Bedford Dwellings Window Replacement & Masonry Repairs IFB#600-27-13

ADDENDUM NO.1

Revised Sill Detail

1 **New Precast Conc. Sills**
Scale: Actual Size

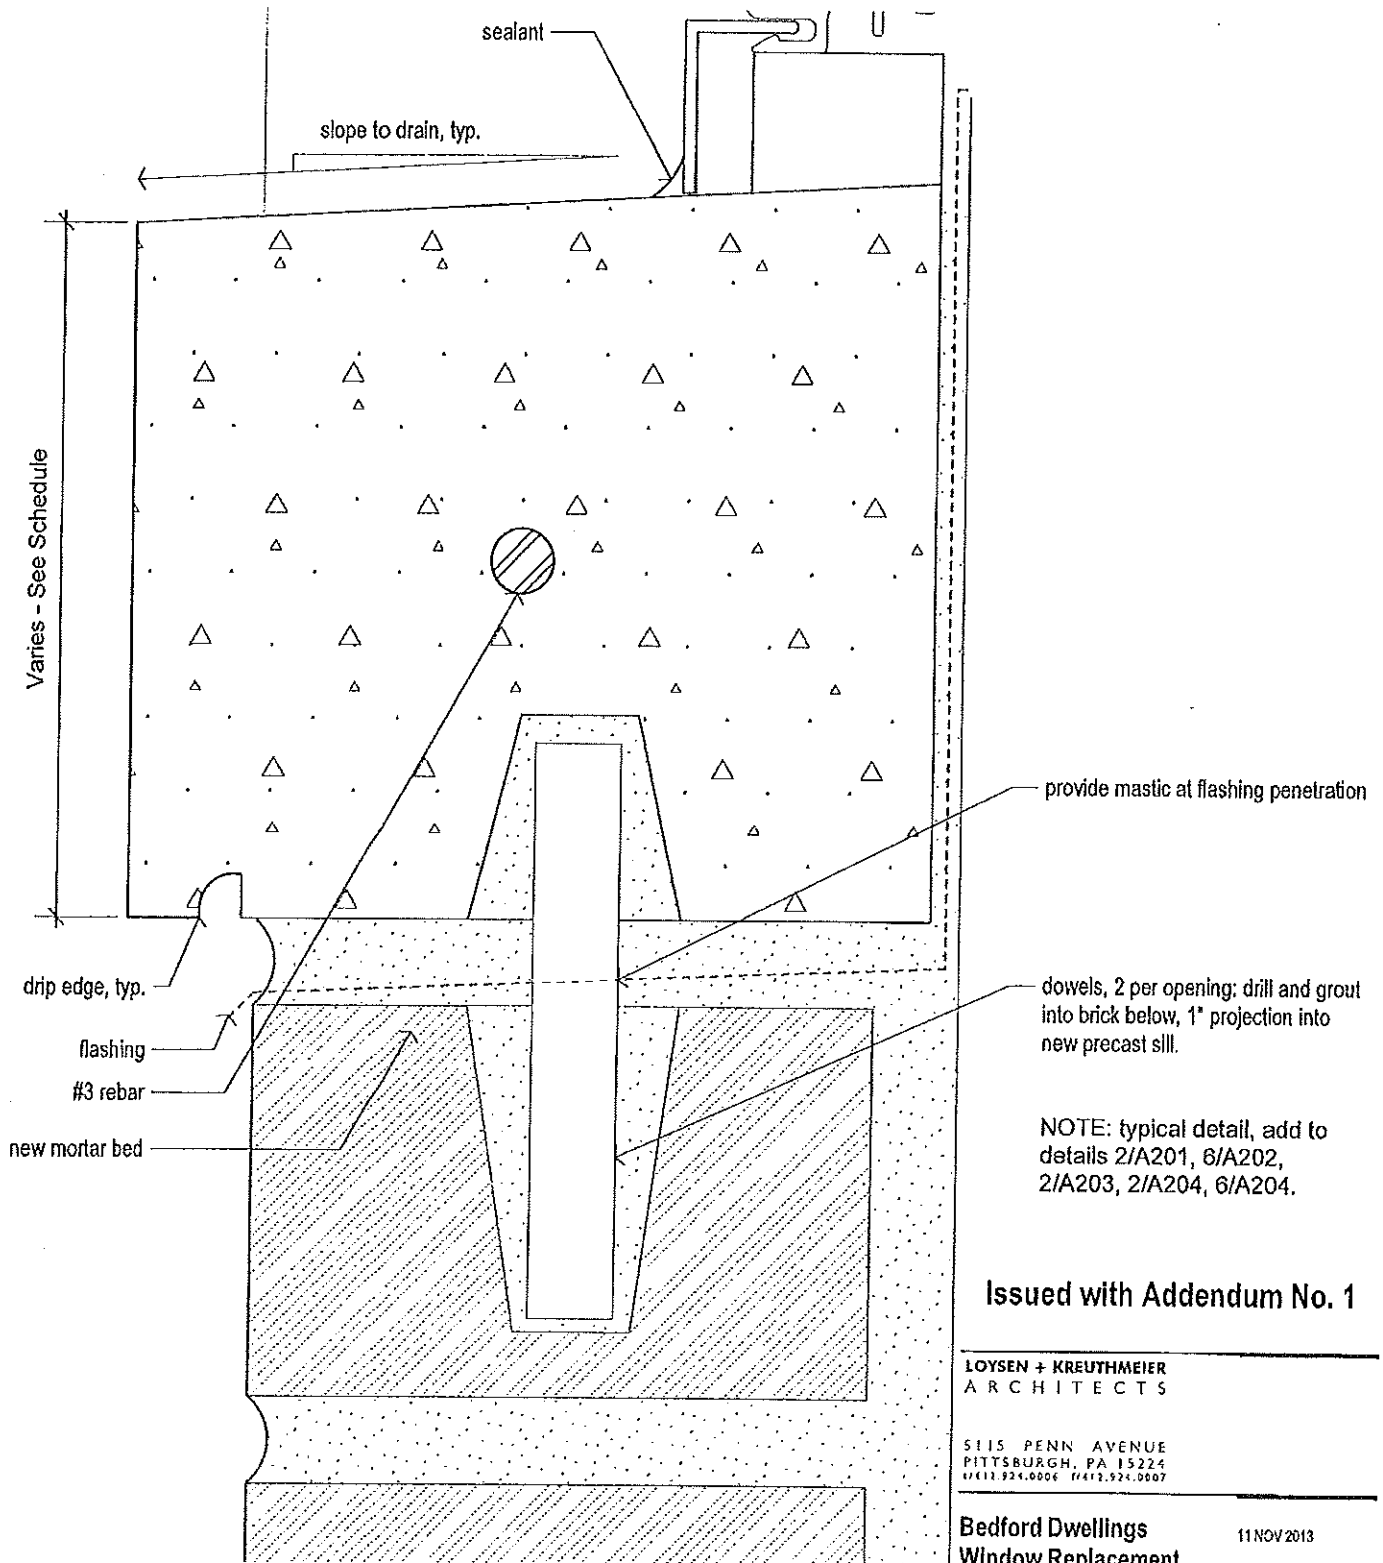
Item 5: Q: Cast Stone specification calls out dowels needed for installation of cast stone sills. Please advise if these are required and if so detail on location & quantity within each stone sill.
A: Dowels are required. See attached Exhibit A (DS1.0) dated November 11, 2013

NOTE: typical detail, add to details 2/A201, 6/A202, 2/A203, 2/A204, 6/A204.
